Addendum No. 4

Project: Guilford County Law Enforcement Center Renovation
Rebid Event # 629

Addendum Date: August 2, 2018

ELEVATOR SMOKE CURTAIN DETAILS

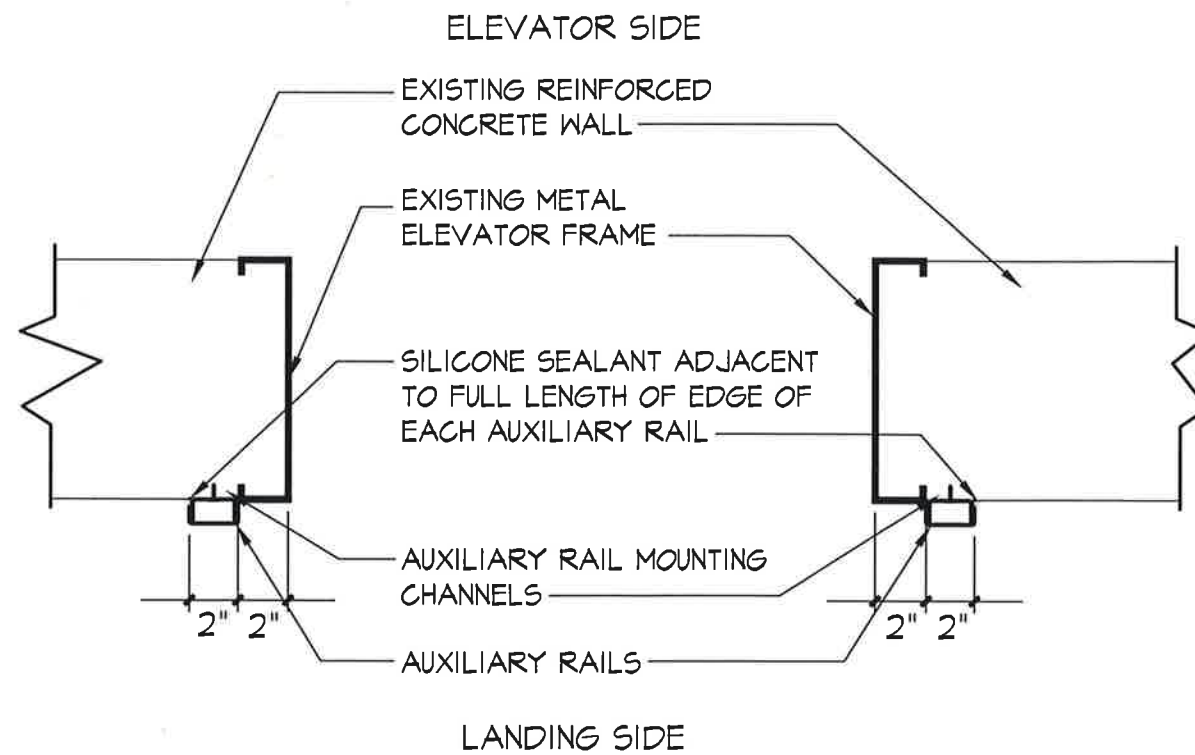
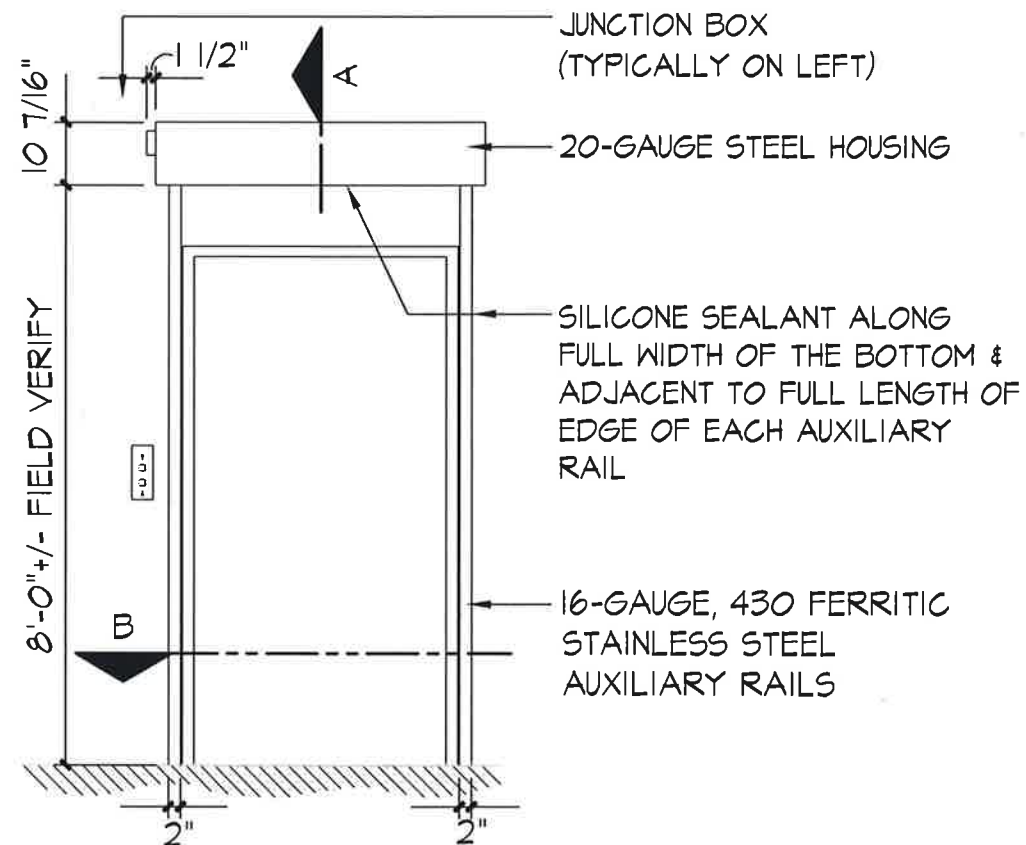
17. A10.4 Detail 10429 Elevator Shaft Single Door: Delete detail. Replace with detail ADD 4-1. (attached)
18. A11.1 Door and Frame Schedule: Delete the following elevator doors/hardware and provide smoke curtains at each opening per spec section 08 34 83: Doors 202A, 202B, 306A, 307A, 402A, 407A, 502A, 507A, 606A, 607A, 702A, 707A, 802A and 807A.

Bulletin No.: BD-FP1

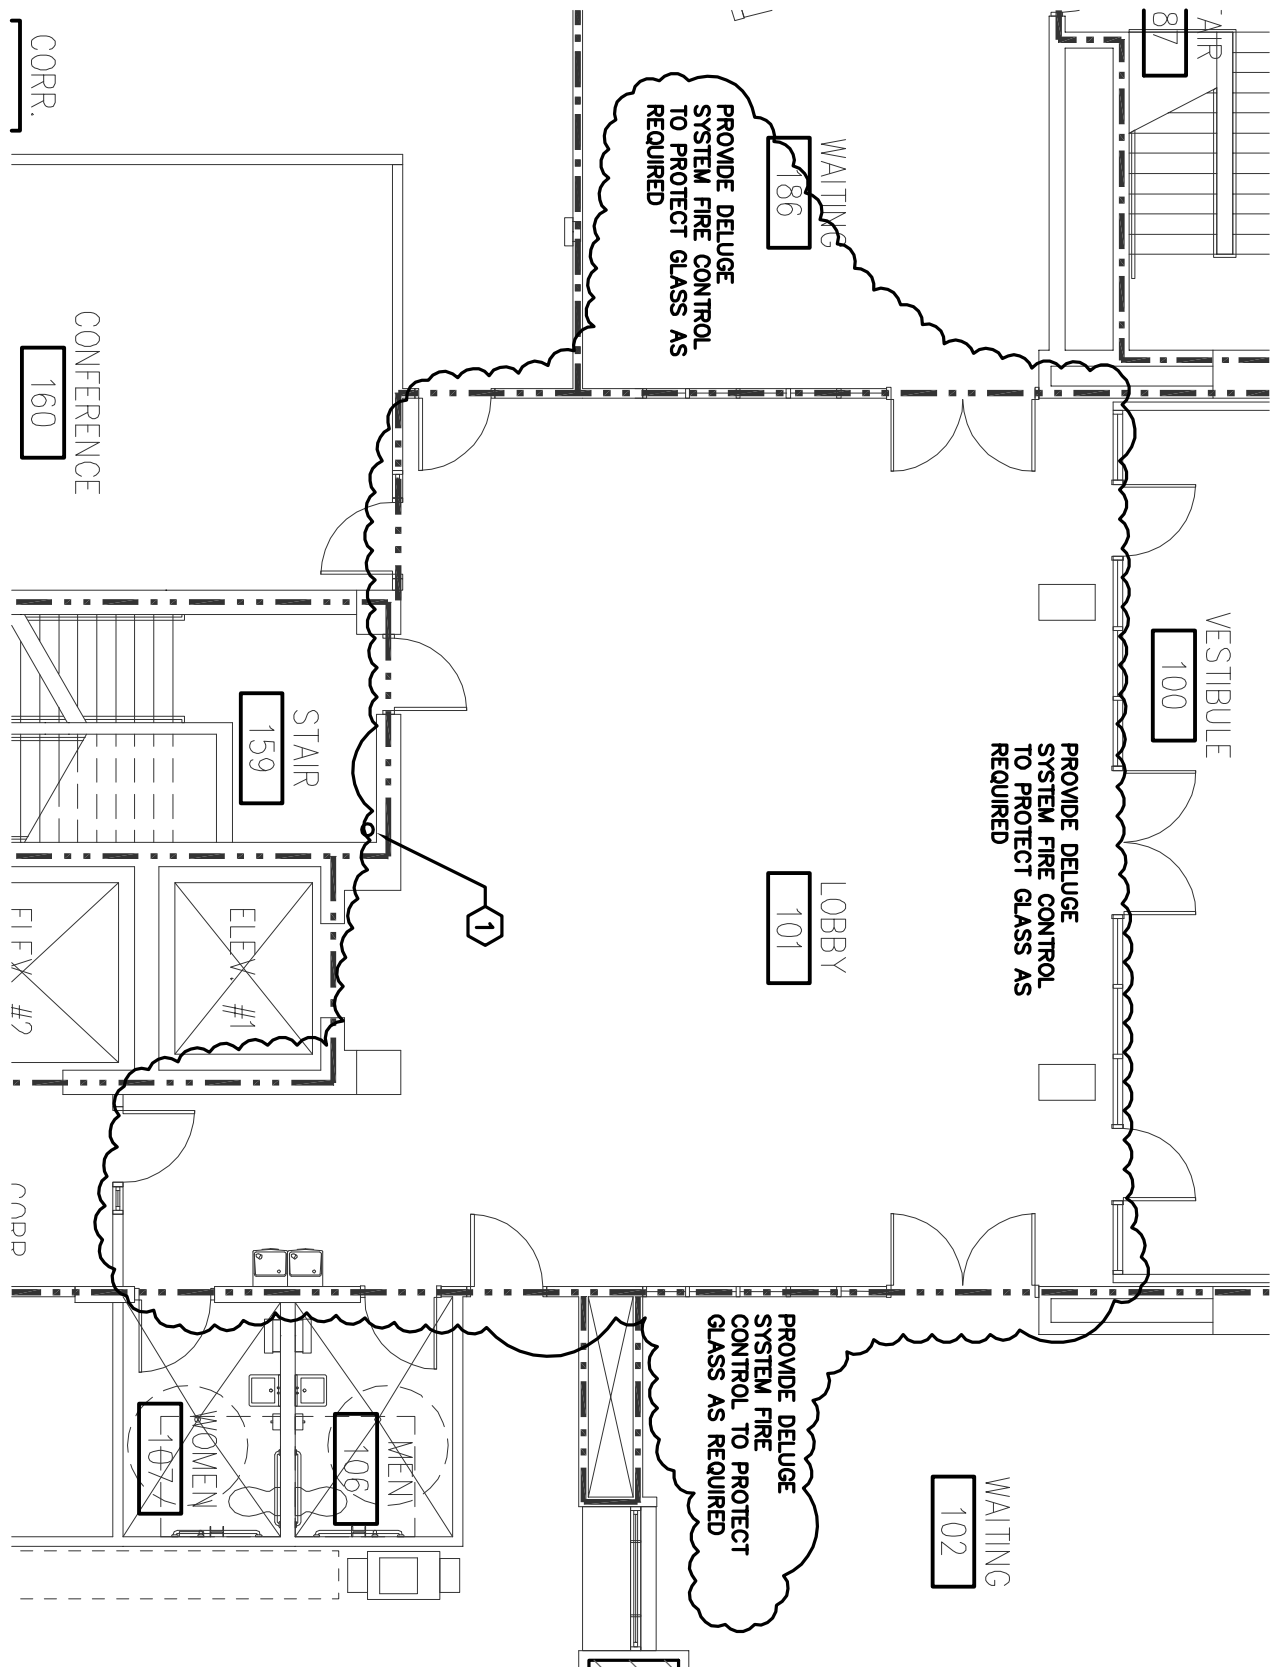
19. FP1.1 Detail 1/FP1.1 - Fire Protection Level 1 Piping – See Bulletin Drawings BD-FP1 (attached)
